Amendment Report for the Application of a Substantive Amendment to the Environmental Authorisation issued for the development of the 140 MW Sutherland Wind Energy Facility, Sutherland, Northern and Western Cape Provinces

DRAFT AMENDMENT REPORT

# APPENDIX C:

Figure 1: Changes in specifications of turbine dimension

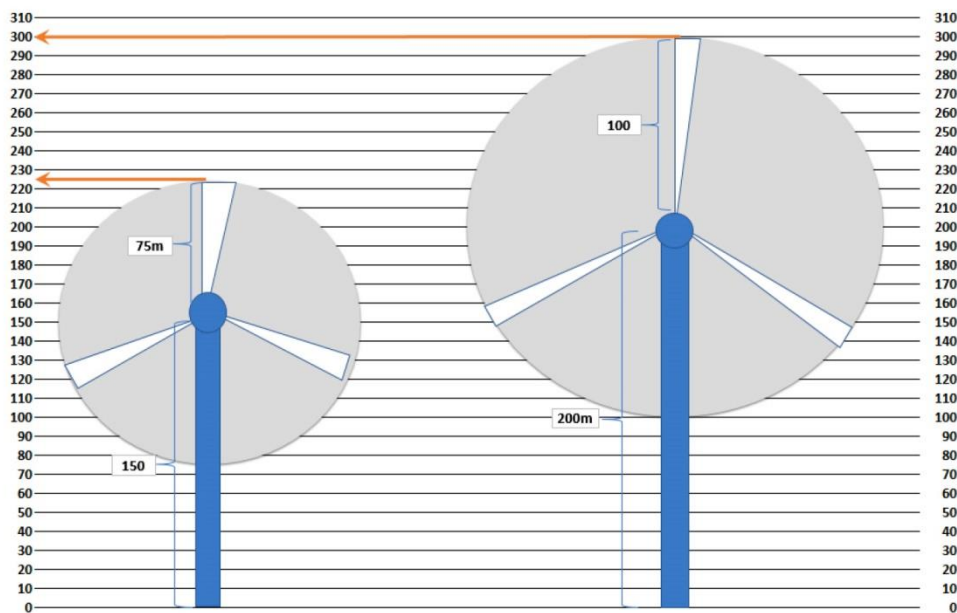
The main negative impact of turbines on bats is the encroachment of air space where bats forage or commute. Table 2 and Figure 1 indicate the increase in the volume of the total sweep area, if turbine sweep is calculated as a sphere. For example, would 39 turbines be installed, with a hub height of 200 m and a rotor diameter of 200 m, there will be a 65,08% increase in sweep area. The lowest point of the sweep of the turbine blades is also indicated, as this could have an impact on bat mortality, see Section 1.1.

- A maximum amount of 39 turbines, with a hub height of 200 m and a rotor diameter of 200 m, is proposed within the provided total output of 140 MW. If more than 39 turbines with these specifications are installed, then mitigations as described in Table 3 will be applicable. Would smaller turbines be deployed, more turbines may be installed, but with agreement of a bat specialist.

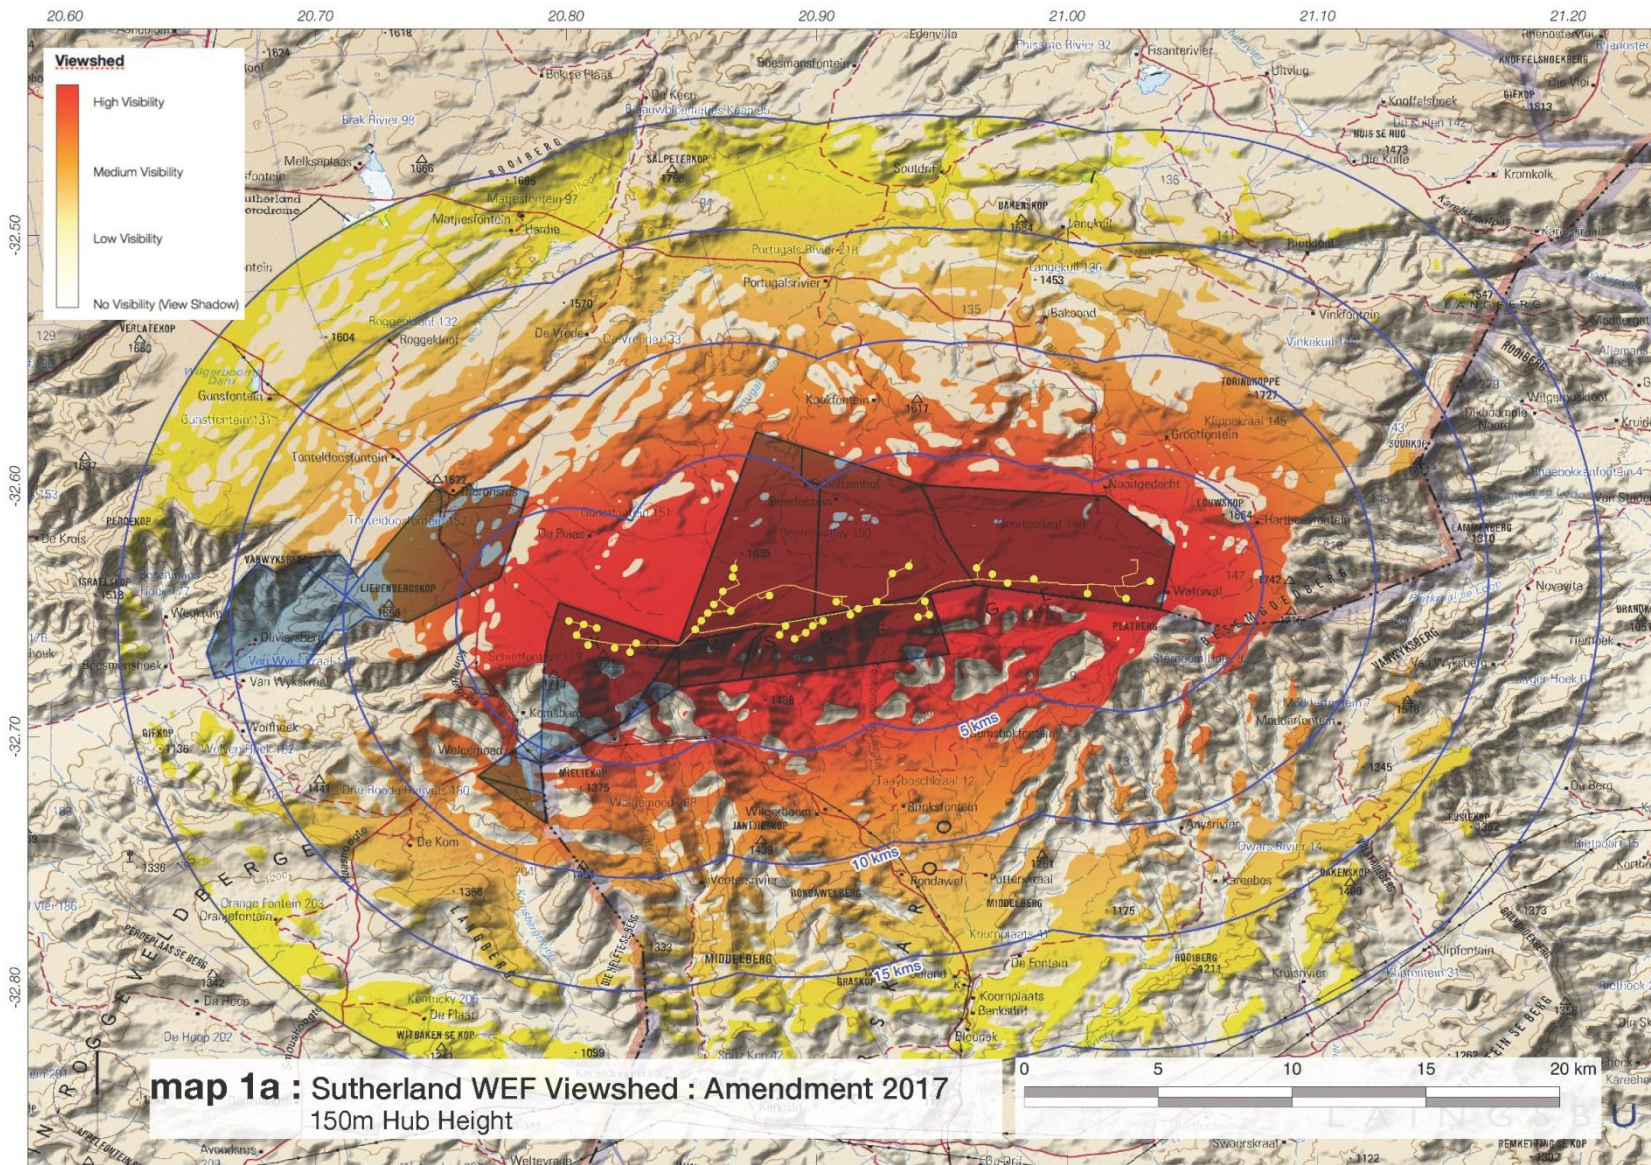
A comparison of the combined viewsheds of the 3 proposed wind farms for the Amendment 2 layout and the current layout is illustrated in Maps 2a and 2b. The difference in visual exposure between these two is shown in Map 2c. Again, the cumulative difference in visual exposure is fairly minimal, but the visual effect on the Komsberg escarpment scenic resource would increase. The cumulative visual effect could be partly offset by increasing the visual buffer from the edge of the escarpment to 660m.

map 3 : Sutherland WEF Escarpment Edge Setbacks : 500m - 660m

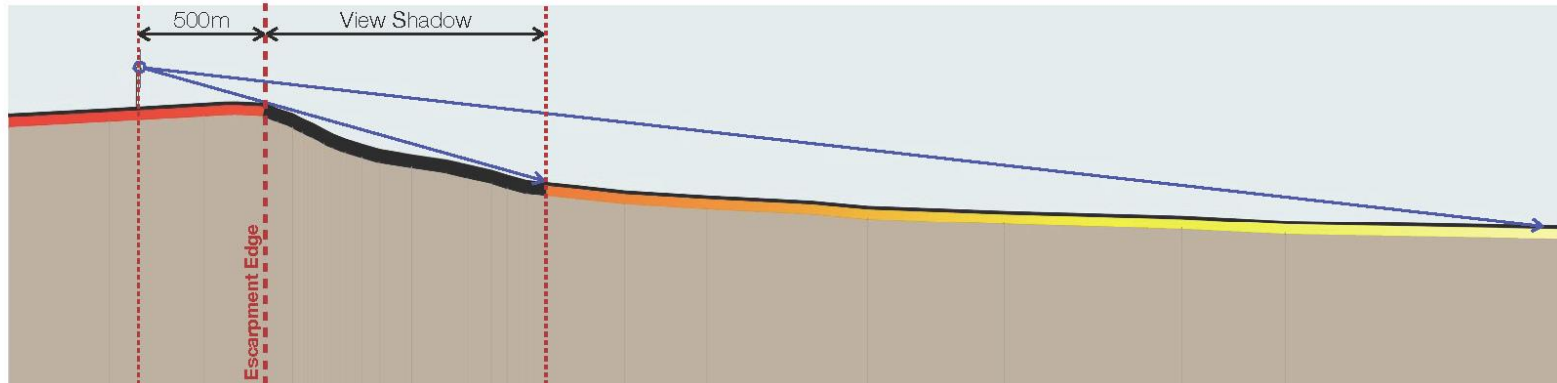
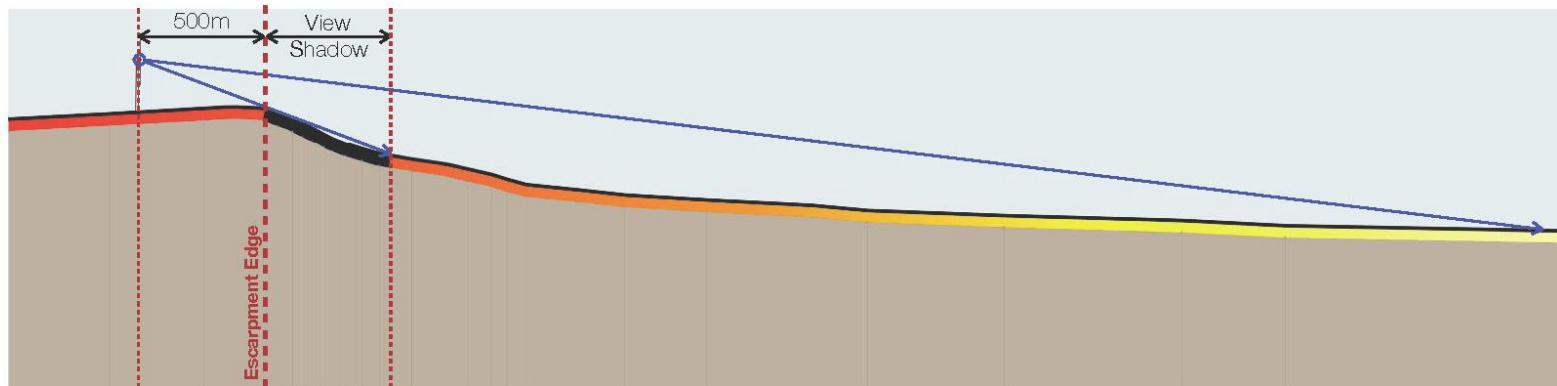
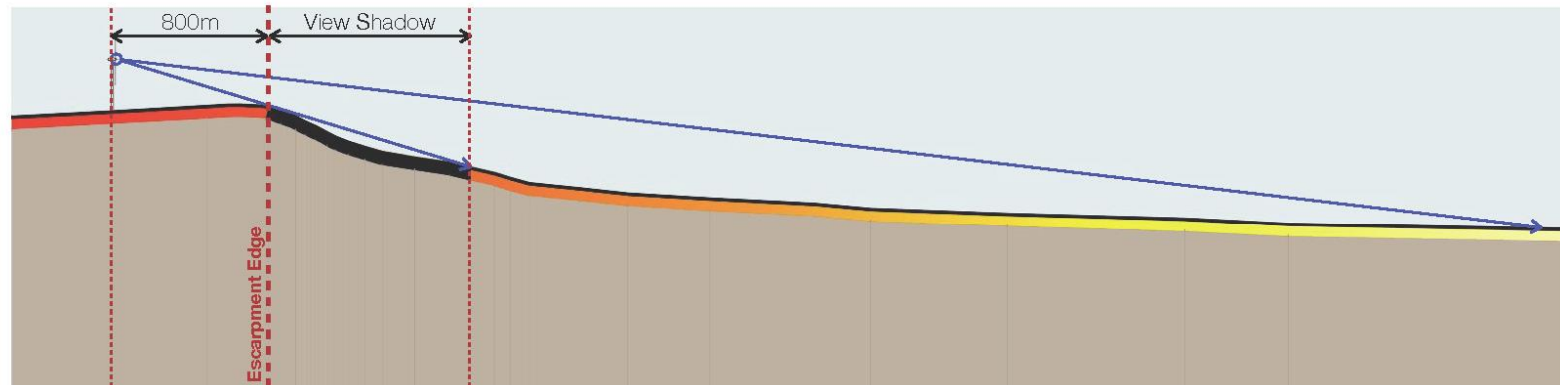
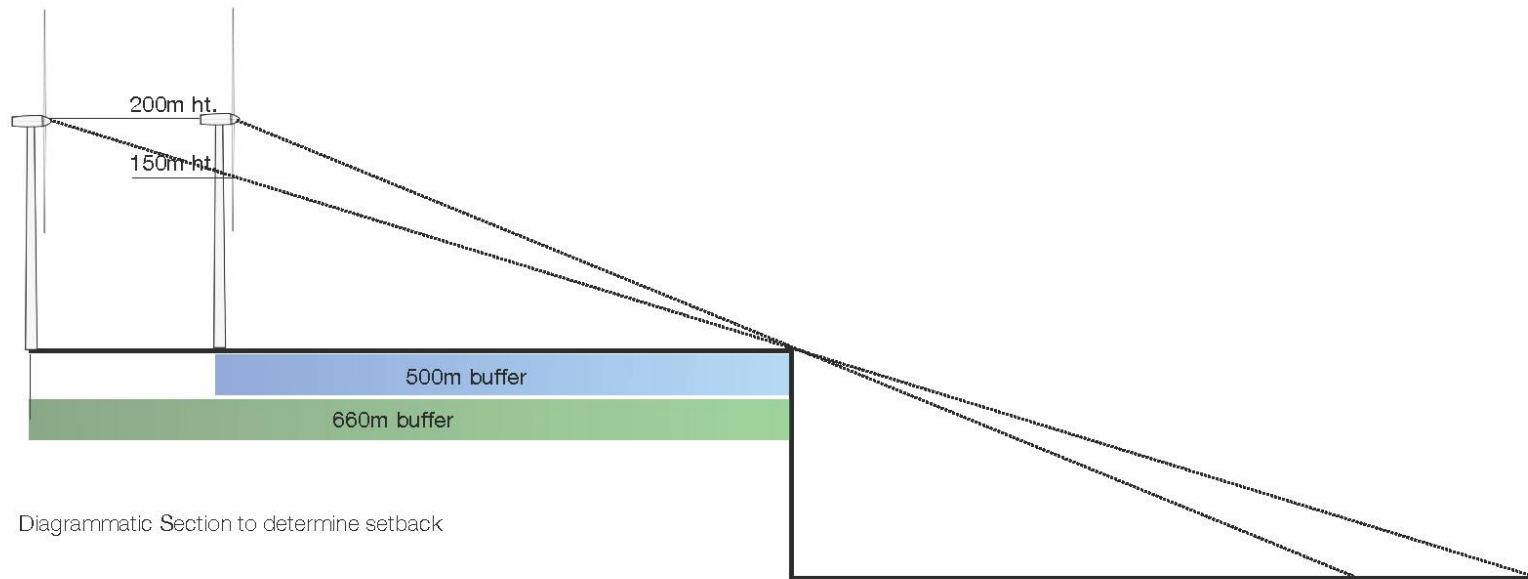
150m Hub Height set back 500m from Escarpment Edge

200m Hub Height set back 500m from Escarpment Edge

200m Hub Height set back 800m from Escarpment Edge
